subject: Addendum Number 1
USC Aiken Etherredge Roof Repairs
Owner Project Number: H29-9550
ADC Project Number: 19065

Addendum Number 1

USC Aiken Etherredge Roof Repairs

Owner Project Number: H29-9550

EXISTING / NEW
 ROOF PLAN

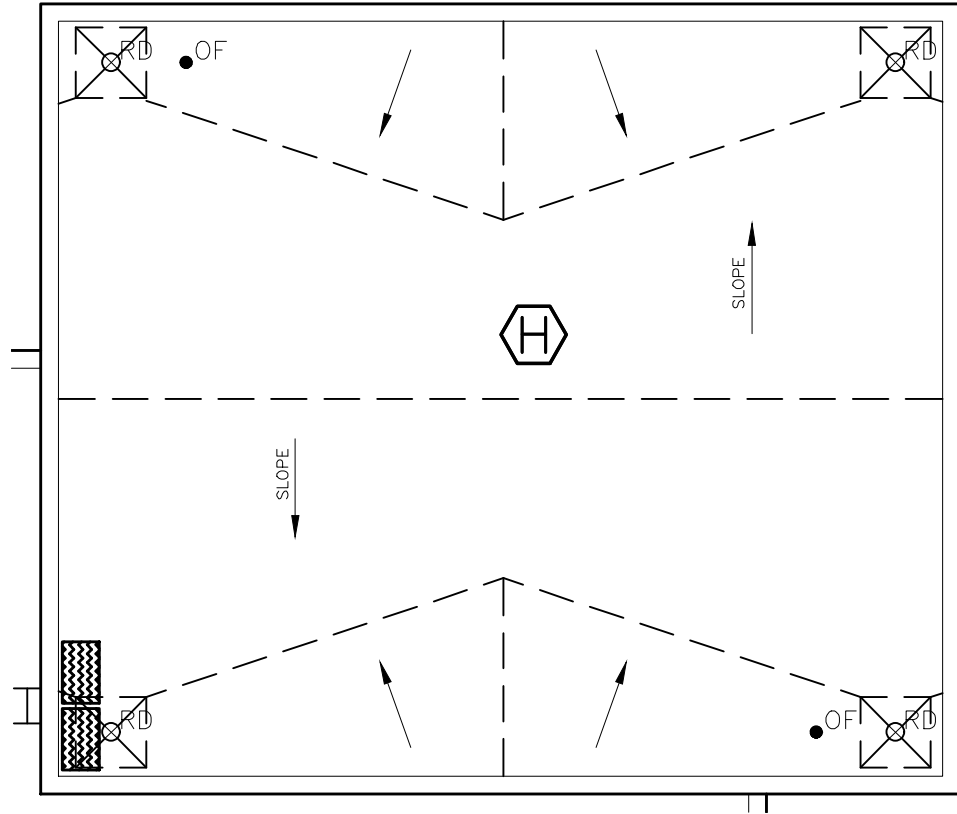
8. What materials/assembly exists for Roof Area H?

- a. See revised drawings, Existing Roof Plan (Addendum Number 1).

TAPER
ROOF PLAN

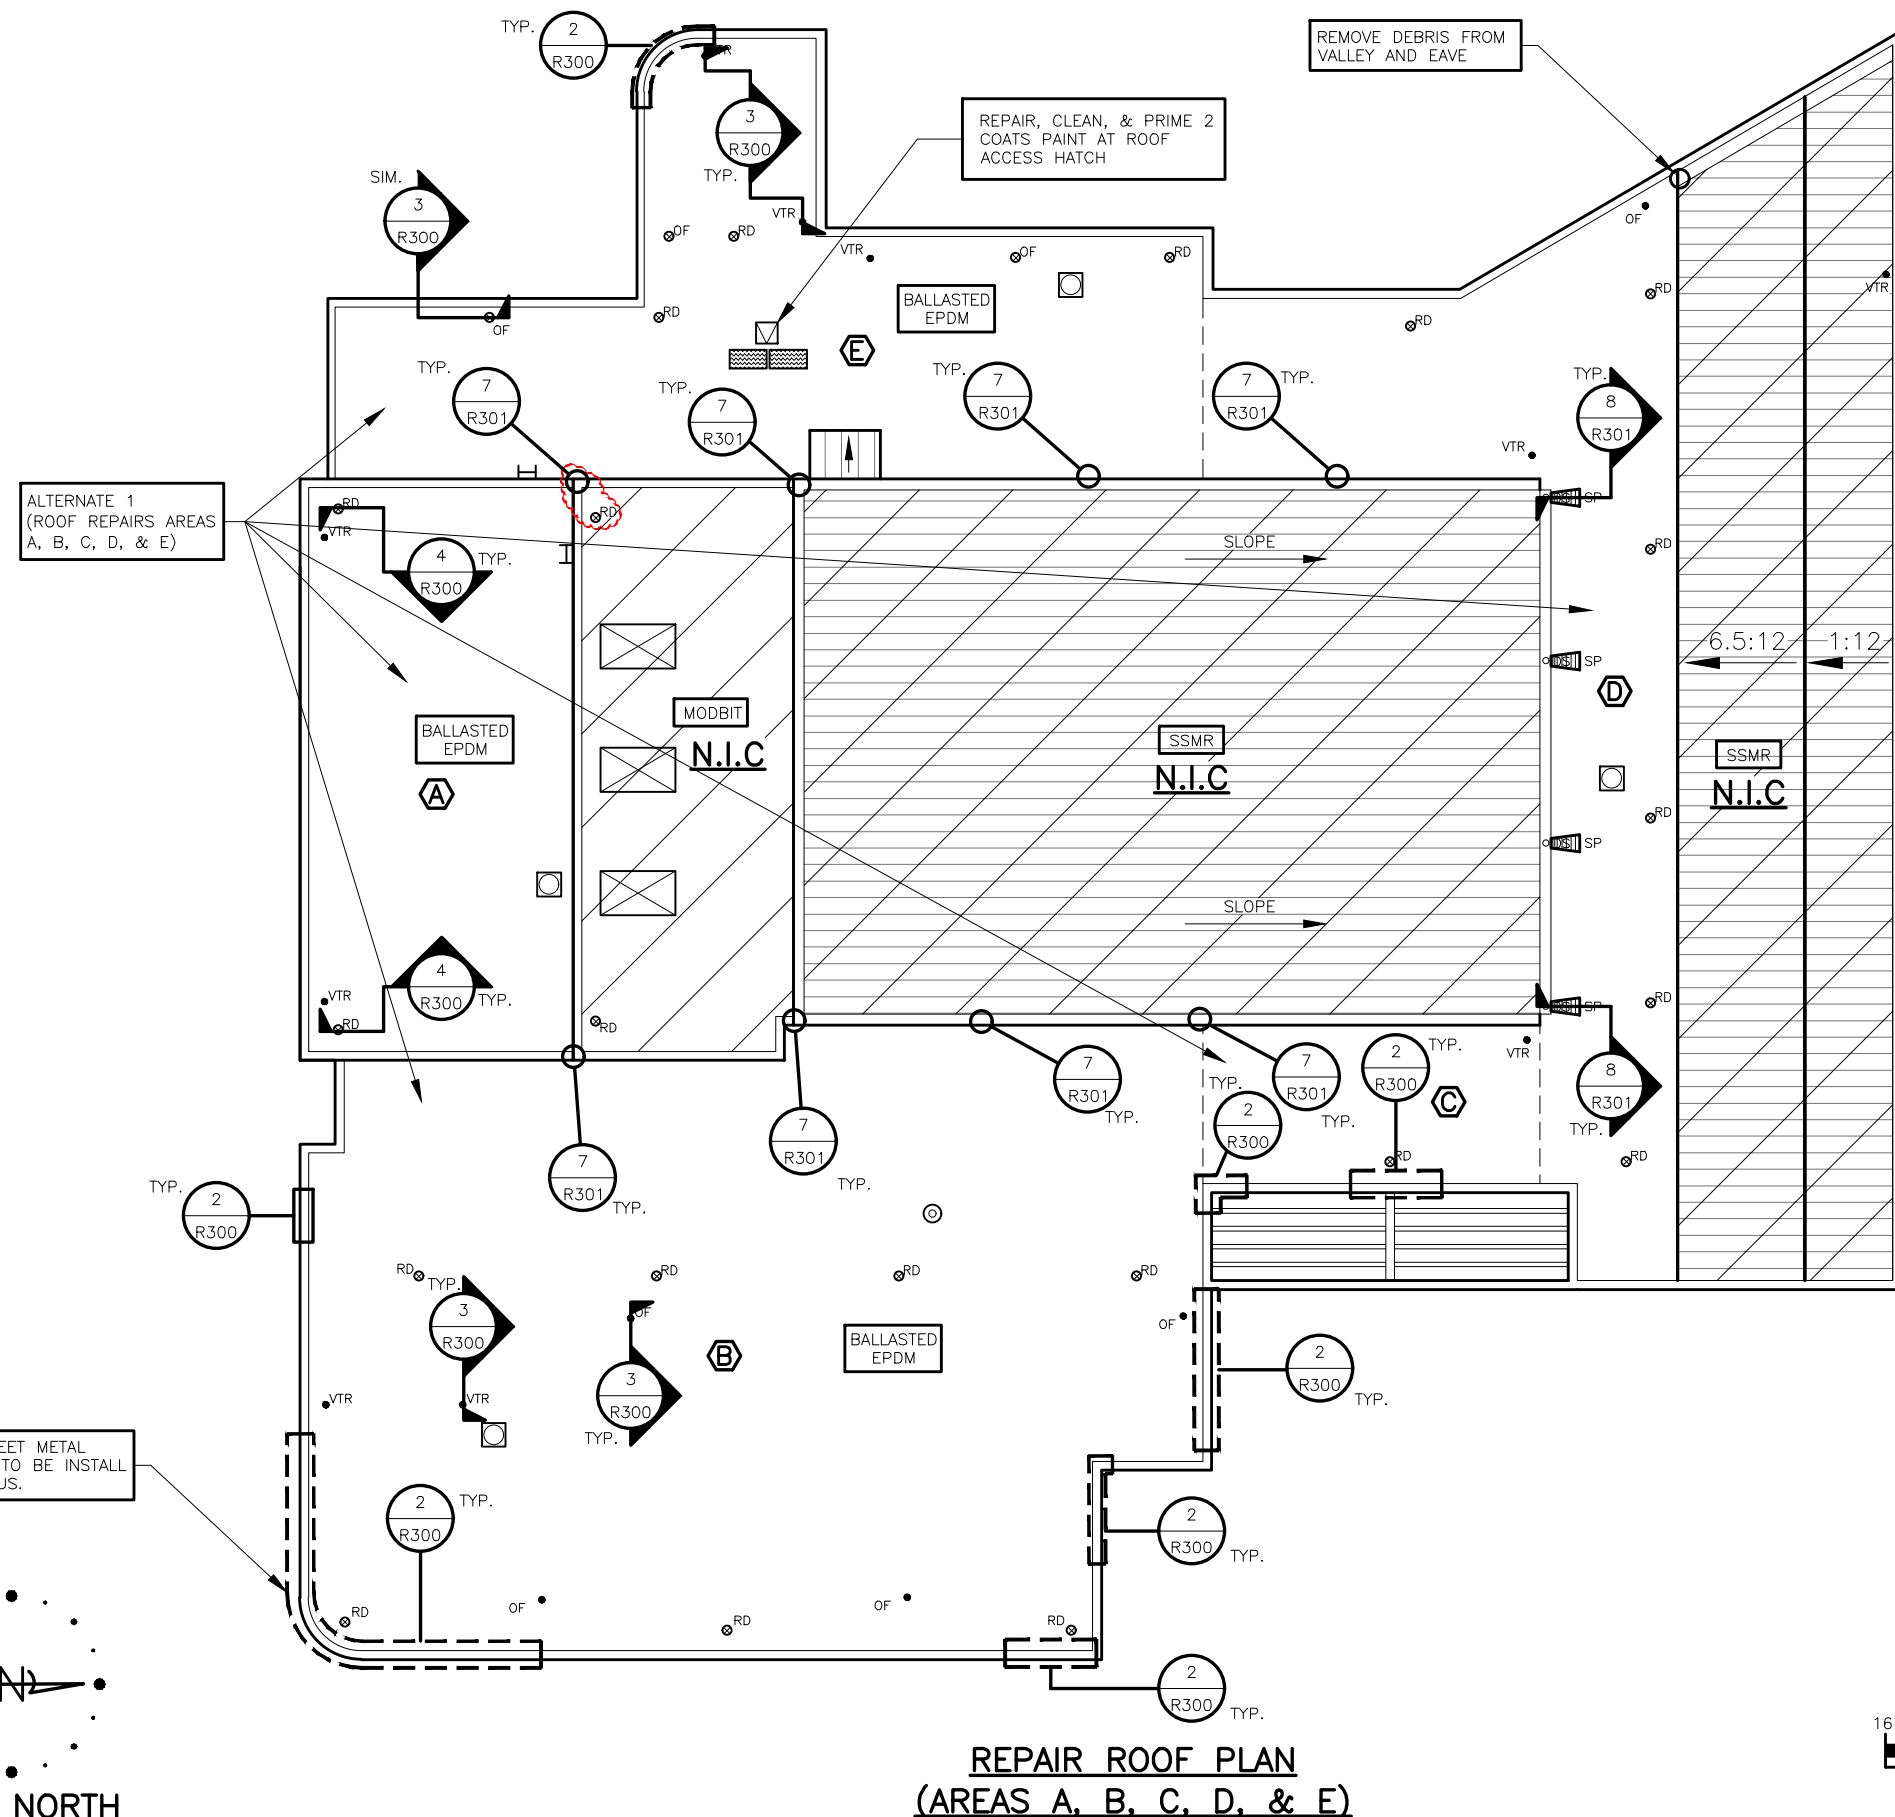
9. Is primary slope in the structure for Roof Area H?

- a. Yes, primary slope is in structure, all secondary slope (tapered insulation) is to be provided in scope. See revised Tapered Roof Plan (Addendum Number 1).

ADDENDUM #1 - LAYDOWN PLAN		LD1
USC AIKEN ETHERREDGE ROOF REPAIRS		
DATE: 07/31/2019	AIKEN, SOUTH CAROLINA	REF: ADDENDUM#1
		ADC PROJECT #: 19065

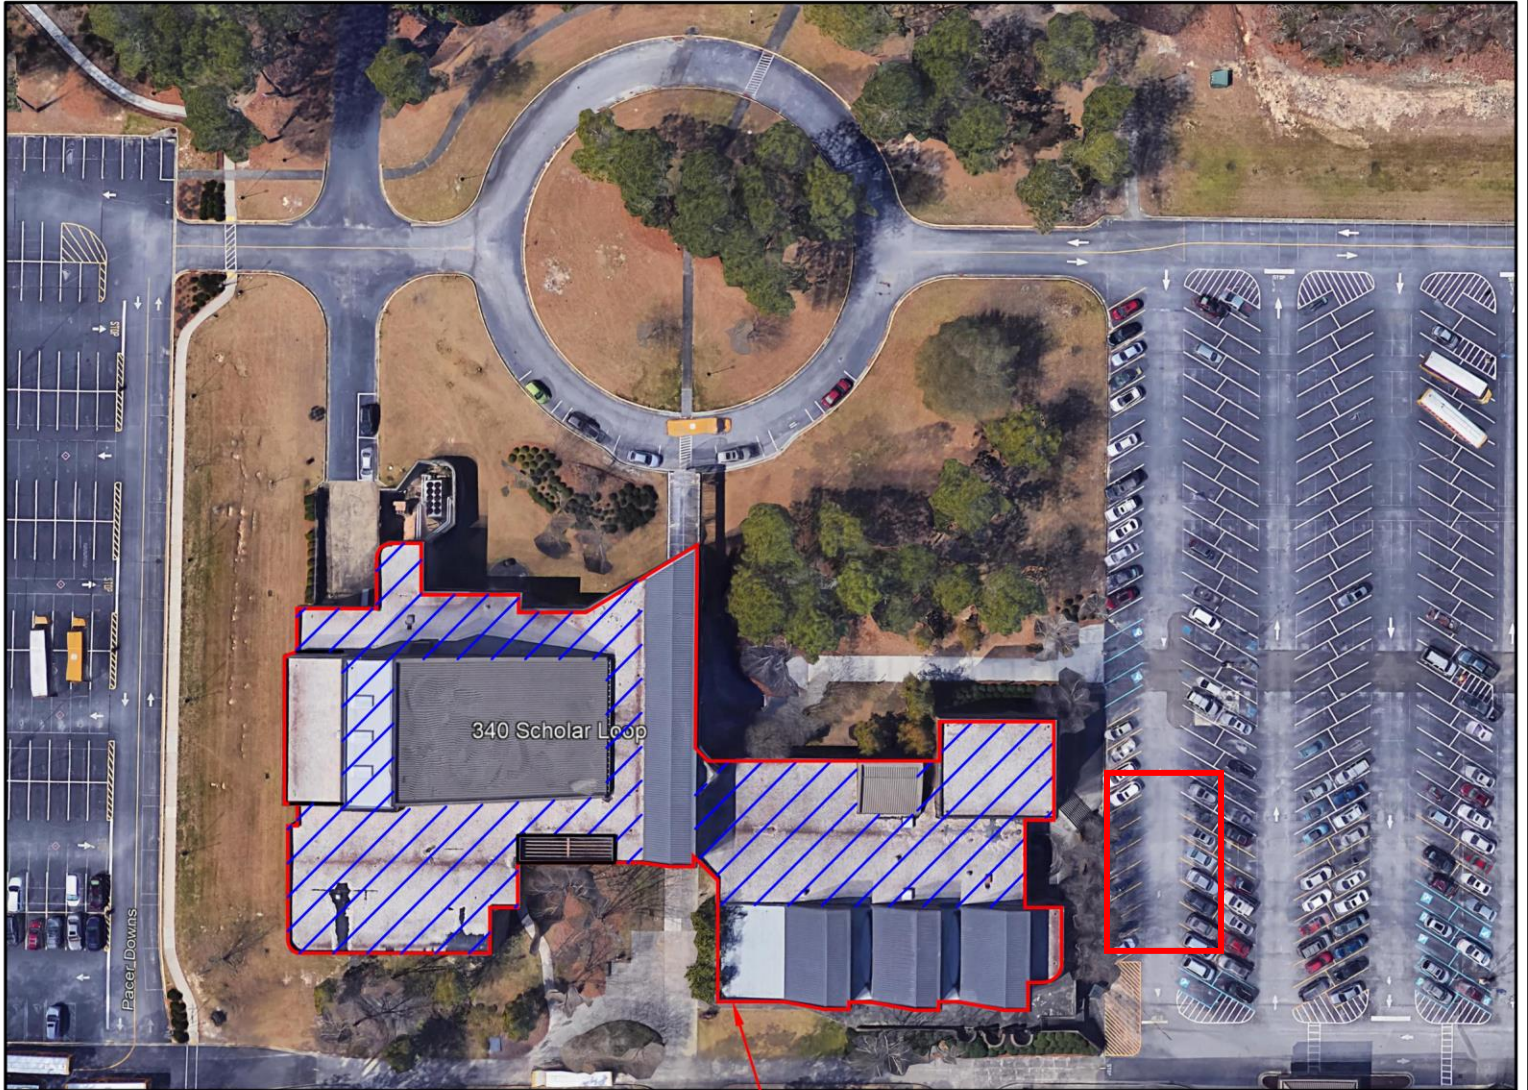
5. What access, laydown and storage is available at the site?

8. Replace all drawings with the revised, attached drawings.
9. See the attached aerial photo of laydown/storage/access area(s).

- a. See the attached aerial site plan.
